# ADDENDUM I FOR TENDER NO. KP1/9AA-2/OT/06-BS/16-17 FOR SUPPLY, INSTALLATION AND COMMISSIONING OF BOUNDARY METERS

# **TECHNICAL CLARIFICATION**

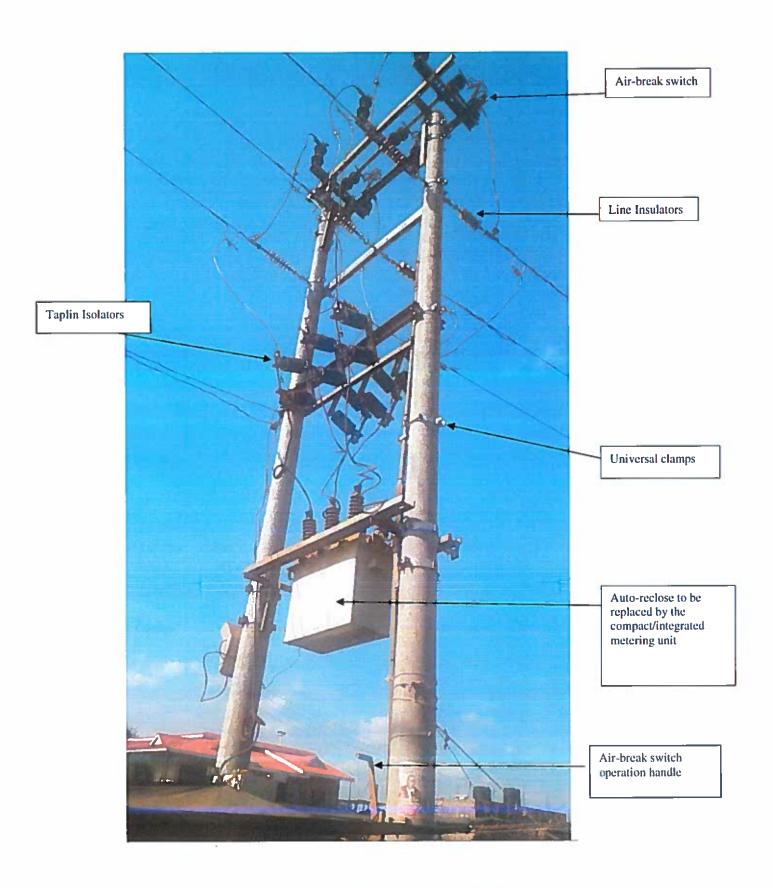
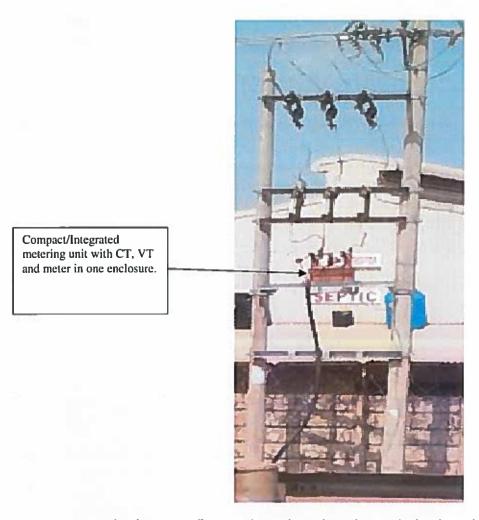
General arrangement drawings with positioning of meter box and dimensions. Are the CTs and VTs mounted on the pole and the energy meter in an enclosure?

KPLC Answer: The general arrangement is as shown below.

There is no separate meter box. The metering unit is integrated as shown below.

An example of a compact/Integrated metering unit can be seen in the picture below. A physical one can be viewed along Mombasa road in the following locations:
